Subject: Notification of Plans to Use Instrumented Inspection Techniques at  
the Davis-Besse Nuclear Power Station

Toledo Edison's letter of April 11, 1988 (Serial No. 1486), notified the NRC of the specific cases where Toledo Edison intended to use Instrumented Inspection Technique (IIT) testing methodology (previously approved by the NRC) during the present refueling outage. The purpose of this letter is to inform the NRC of one additional case for which Toledo Edison intends to utilize IIT during the outage.

# DRAWING CHANGE NOTICE

DRAWING NO.	REV.
12501-M-006D	14
DCN NO.	
M-006D-44

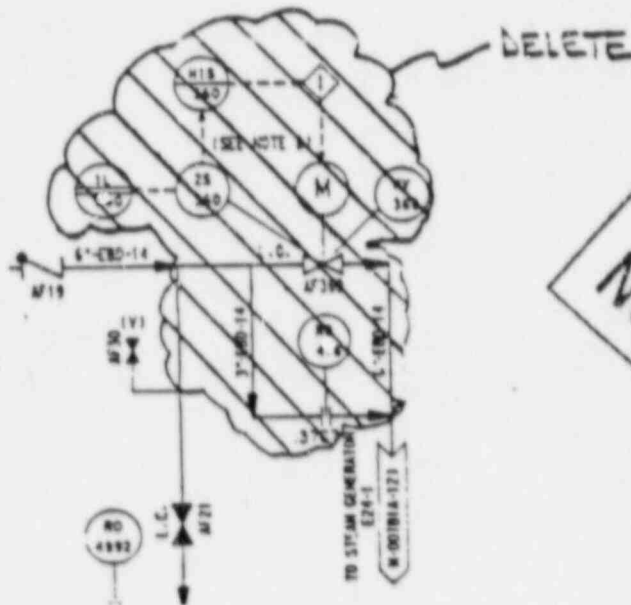
THIS DCN SUPERSEDES DCN NO. M 006D-37.

INFO NOTE: THIS DCN IS FOR CHANNEL 1 ONLY.

DRAWING NO	REV NO
12501-M-006D	14
DCN NO	
M-006D-44	
PAGE	OF
2	3

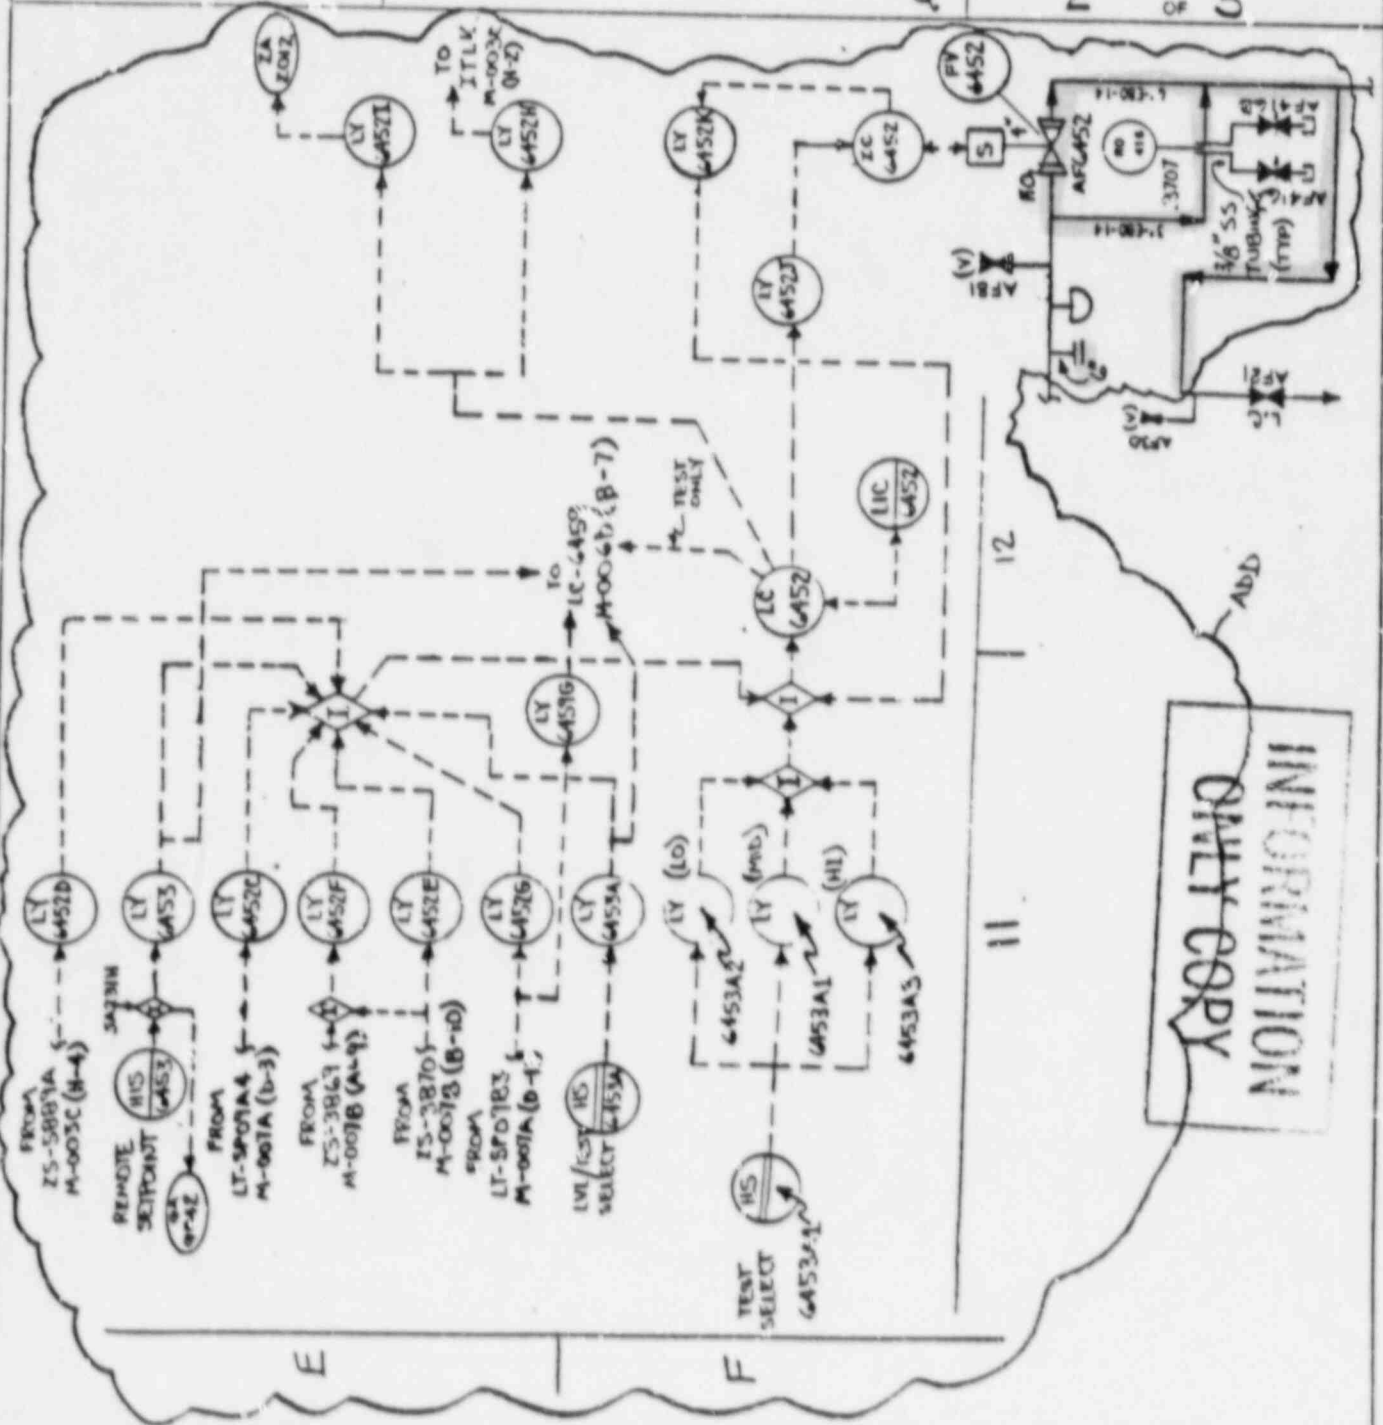
INFO. NOTE: WORK THIS PAGE AFTER PAGE 1.

DRAWING NO.	REV. NO.
12501-M-006D	14
DCN NO.	
M-006D-45	
PAGE	OF
3	3

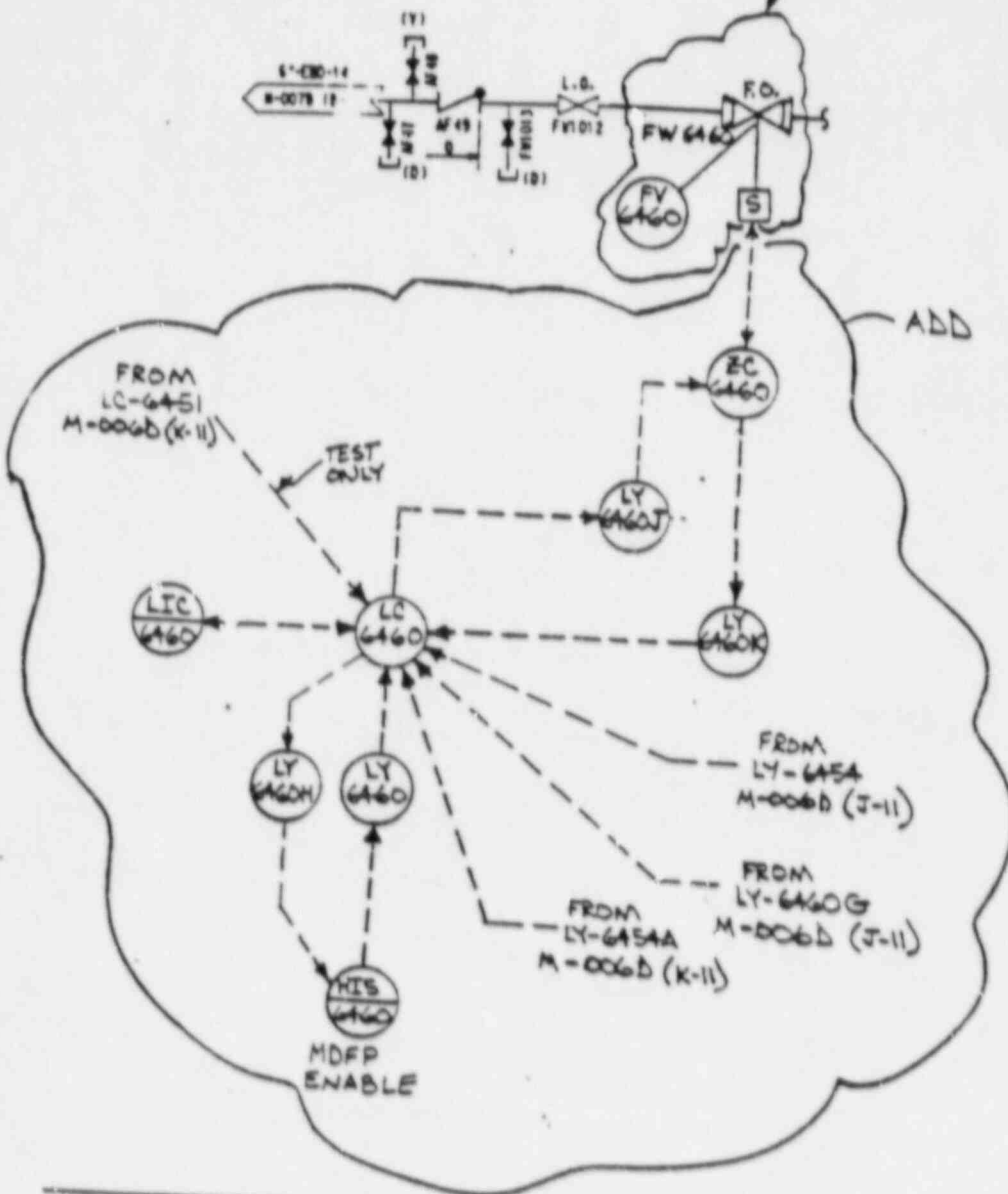
ADDED BY FCR 86-425.  
 SHOWD HERE FOR CLARITY.

DRAWING NO.	REV. NO.
12501-M-007B	8
DCN NO.	
M-007B-30	
PAGE	
2	OF 2

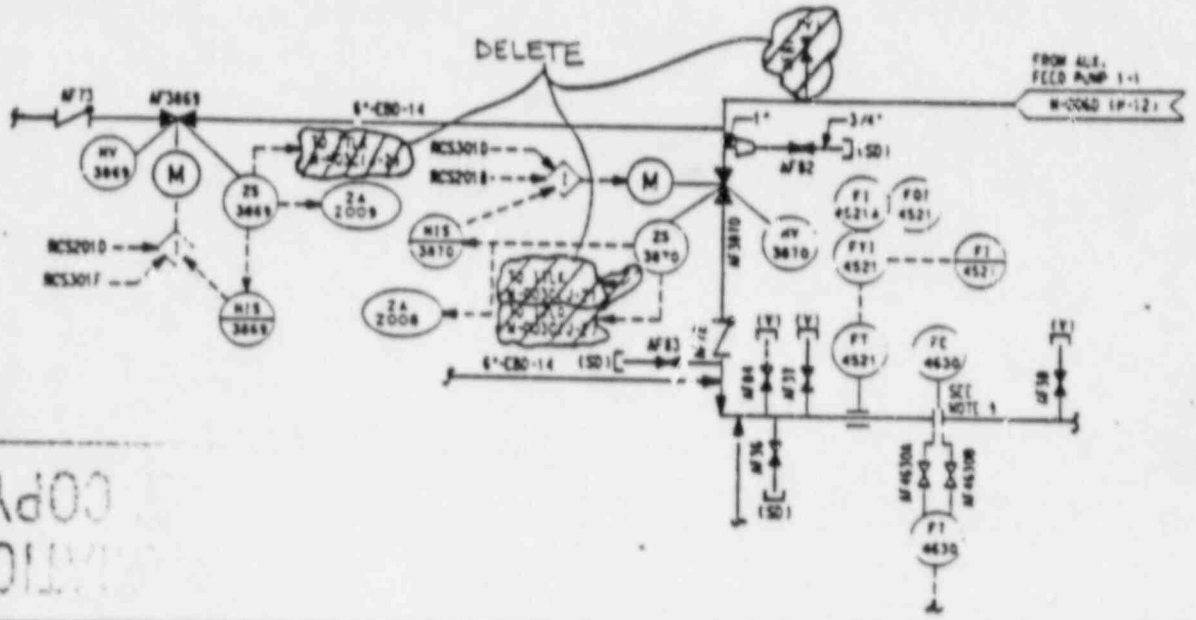
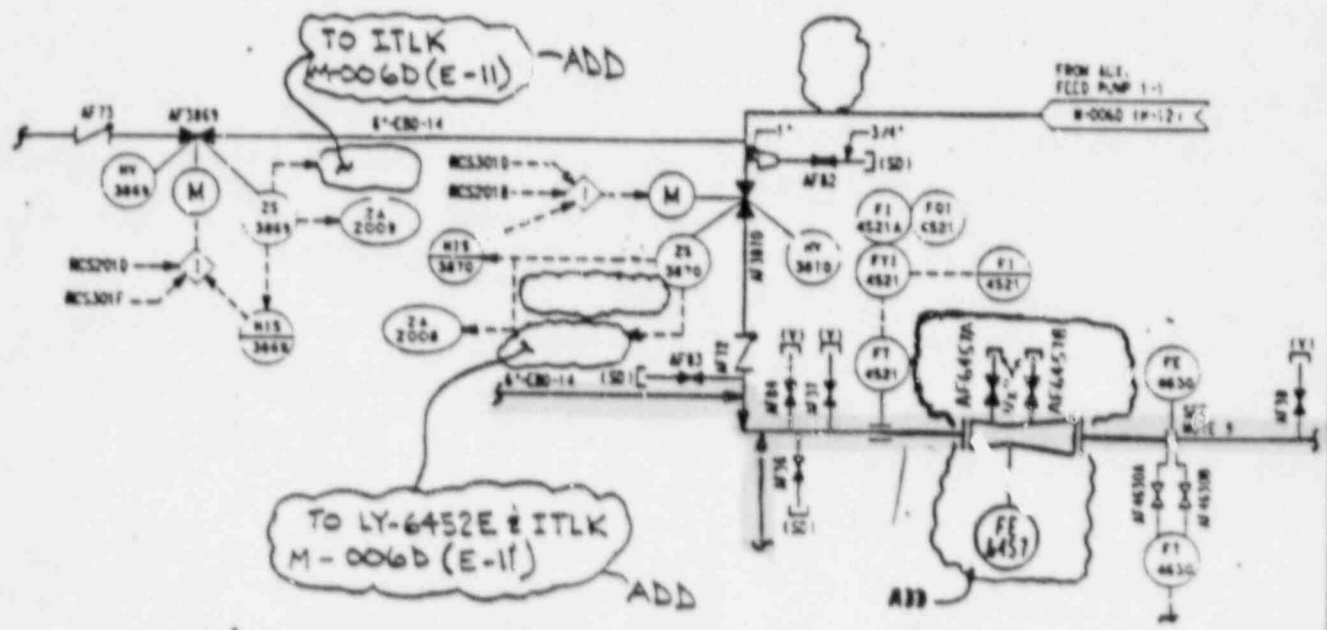
DESCRIPTION OF CHANGE: THIS DCN SUPERSEDES DCN NO. M-007B-23.

INFO  
 NOTE: THIS DCN IS FOR CHANNEL 1 ONLY.

DRAWING NO	REV. NO.
12501-M-007B	8
DCN NO	
M-007B-31	
PAGE 2 OF 2

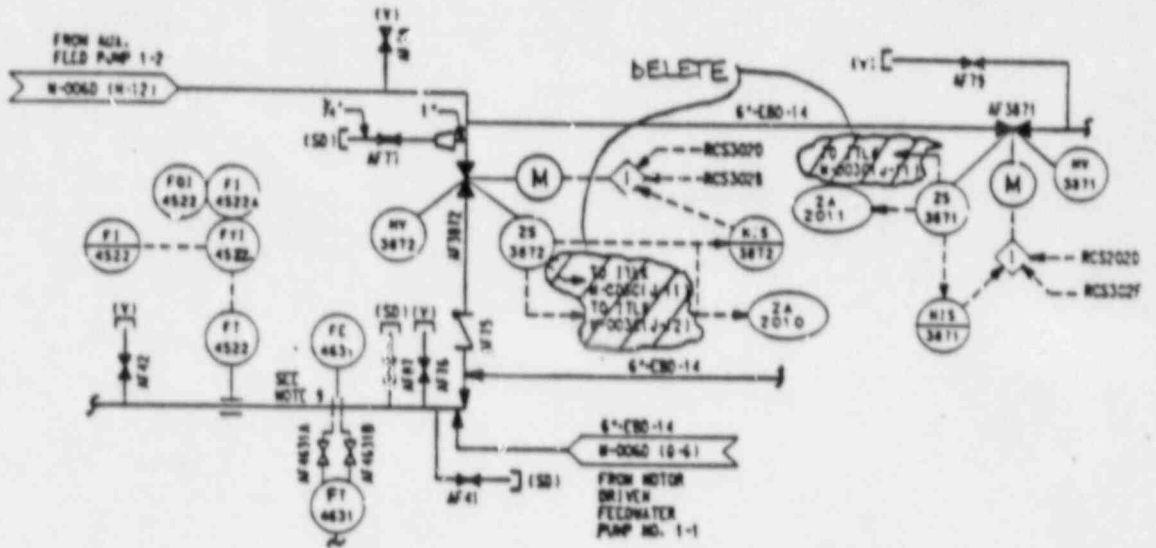
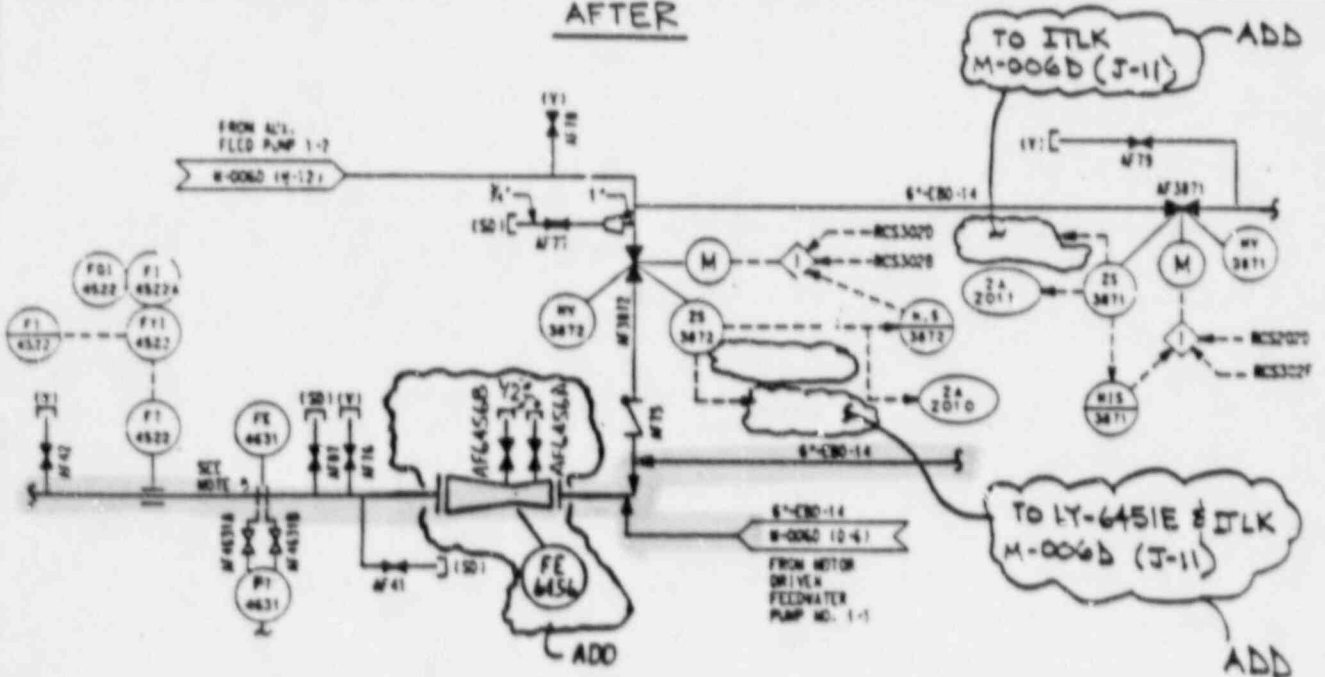
DESCRIPTION OF CHANGE: THIS DCN SUPERSEDES DCN NO. M-007B-22.

INFO.  
 NOTE: THIS DCN IS FOR CHANNEL 2 ONLY.
